SUBJECT: COMANCHE PEAK NUCLEAR POWER PLANT, UNITS 3 AND 4
DOCKET NUMBERS 52-034 AND 52-035
RESPONSE TO REQUEST FOR ADDITIONAL INFORMATION NO. 4308, 4309, 4310,
AND 4311

Response to Request for Additional Information No. 4308 (CP RAI #138)

Comanche Peak, Units 3 and 4

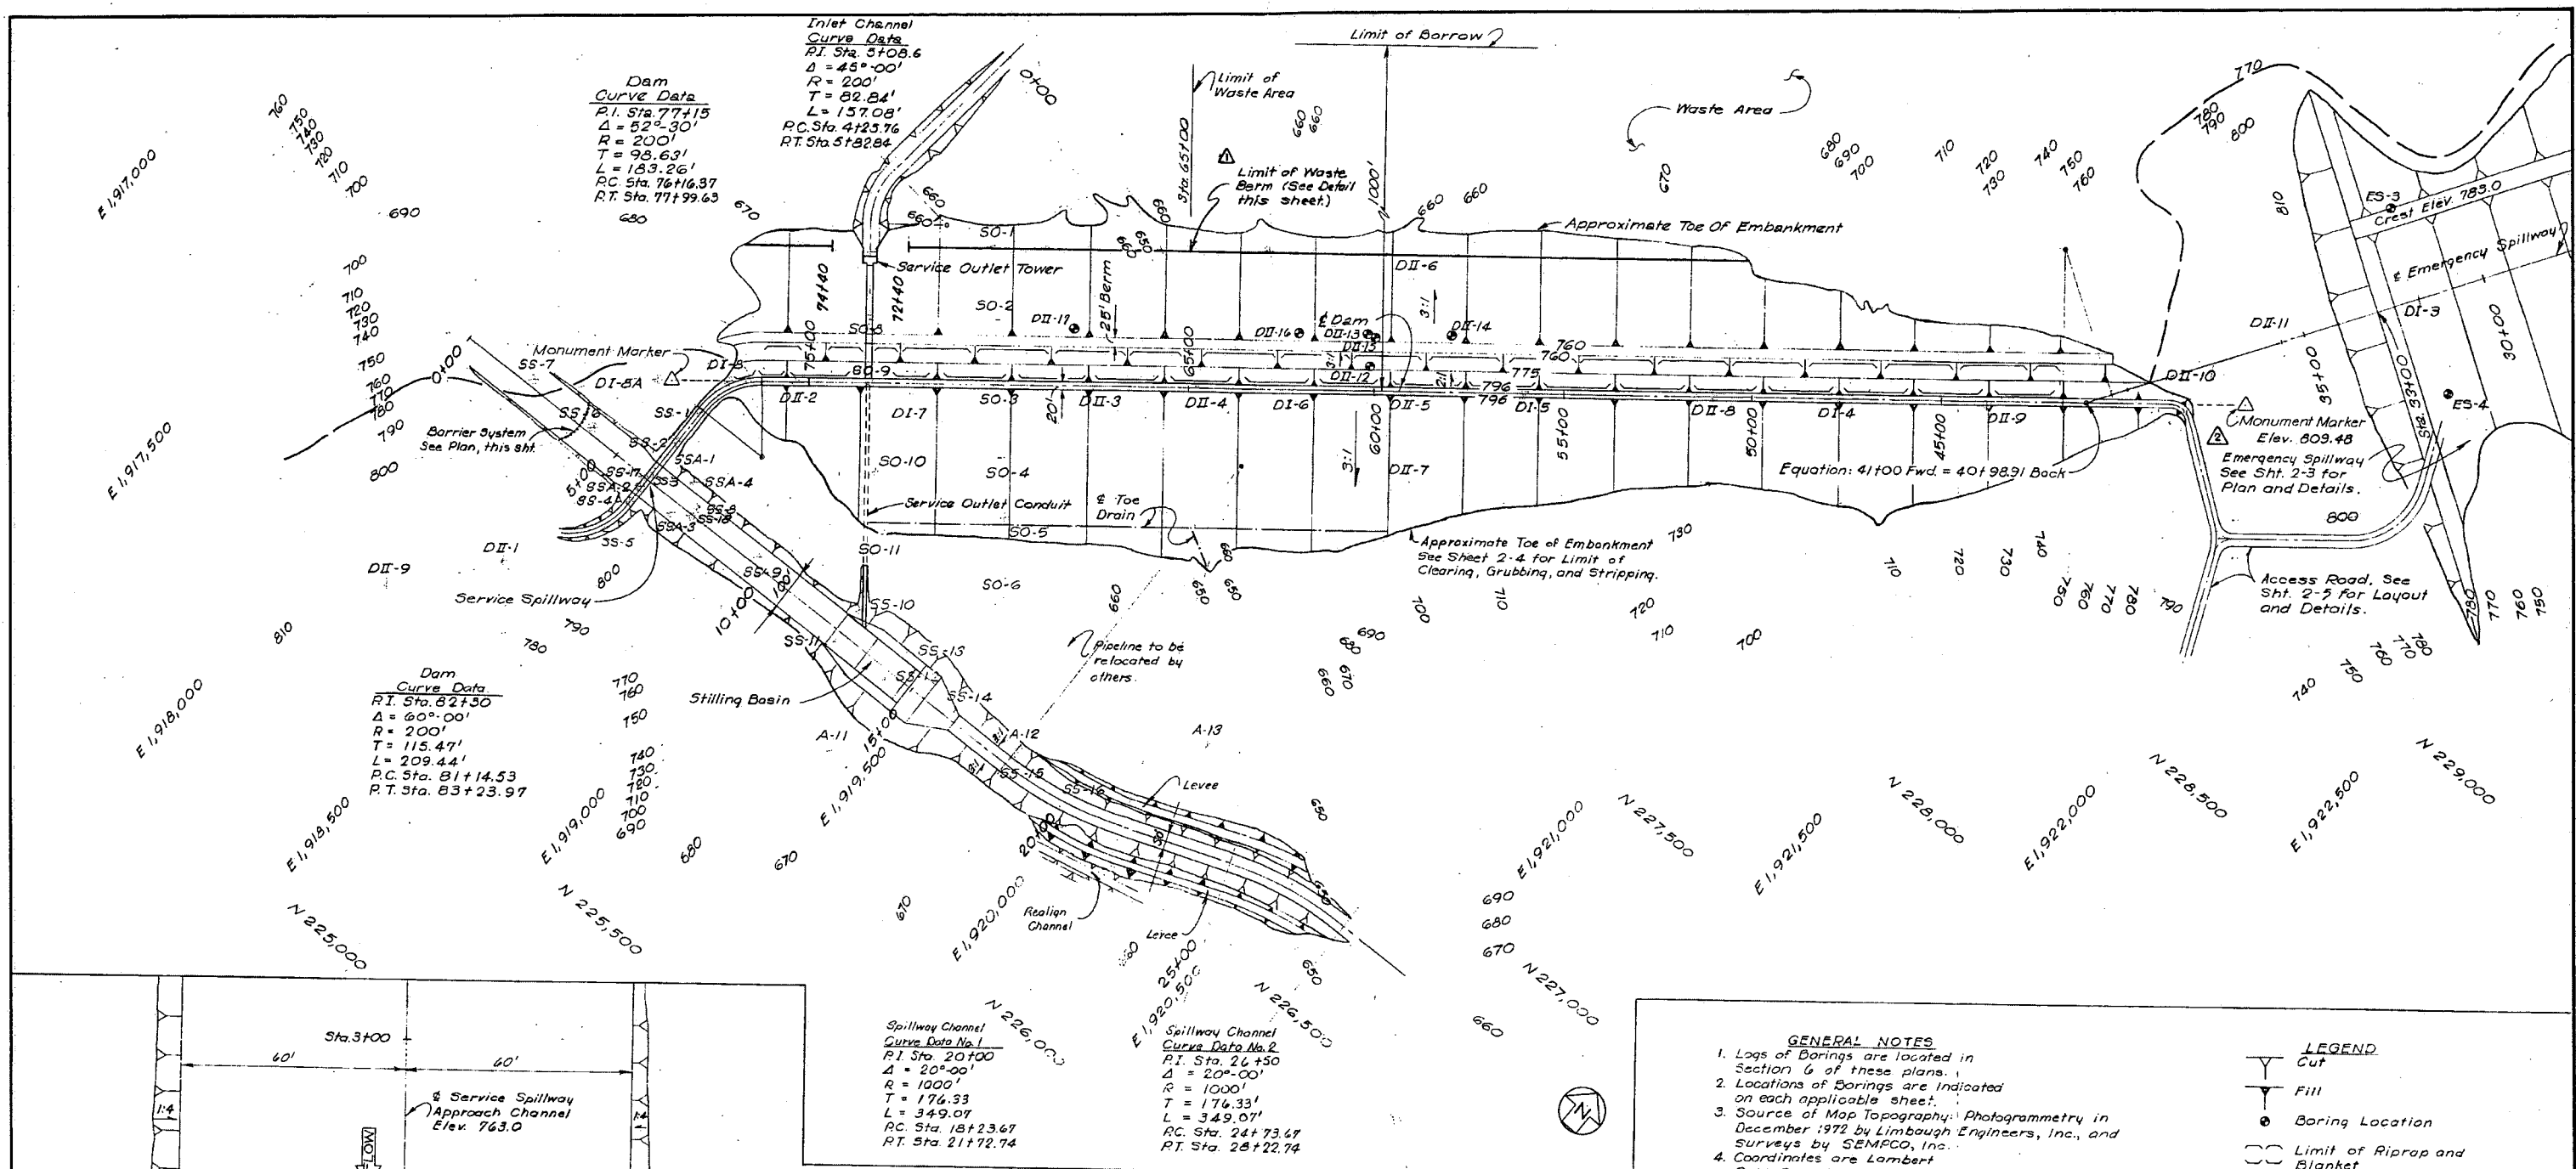
Accordingly, the NRC staff requests that the applicant provide:

The calculation has been revised to reflect the most recent available volumetric survey conducted in 2007. Therefore, the revised calculation utilizes the 2008 Volumetric Survey for the stage storage relationship up to and including elevation 775 ft. The Operation and Maintenance Procedures are utilized for data above elevation 775 ft. The 2008 Volumetric Survey utilized the same methodology as the previous volumetric survey to perform the updated hydrographic survey. The revised stage storage relationship is tabulated below.

In addition, the calculation has been revised to reflect new spillway discharge rating curves utilizing the methods of the U.S. Bureau of Reclamation Design of Small Dams for the service spillway with an ogee crest and the methods of the Federal Highway Administration Hydraulic Design Series Number 5 for the emergency spillway. The reconstituted spillway discharge rating curves are more conservative than those previously used and account for submergence due to assumed tailwater effects.

For the 100-ft wide service spillway with an ogee crest elevation of 775 ft, a design head of 25 ft, or elevation 800 ft, was selected. This is more conservative than the recorded design head of approximately 15 ft. Based on the record drawing approach height for the spillway of 12 ft, the ogee crest discharge coefficient is determined to be 3.78. Accounting for the depth of overtopping flow up to elevation 795 ft, the ogee crest discharge coefficient is reduced to range from 3.02 to 3.67 for an overtopping depth from 1 ft to 20 ft. Because the ogee crest has a 45 degree sloping upstream face, the ogee crest discharge coefficient is increased to range from 3.06 to 3.71.

The revised backwater analysis as discussed in the response to Question 02.04.03-5 above determined that the water surface elevation on the downstream face of the Squaw Creek Dam would reach elevation 760.39 ft. This elevation is below the ogee crest spillway, indicating no submergence due to tailwater effects would occur. However, the conservative assumption that the spillway crest is submerged is retained for the PMF analysis.
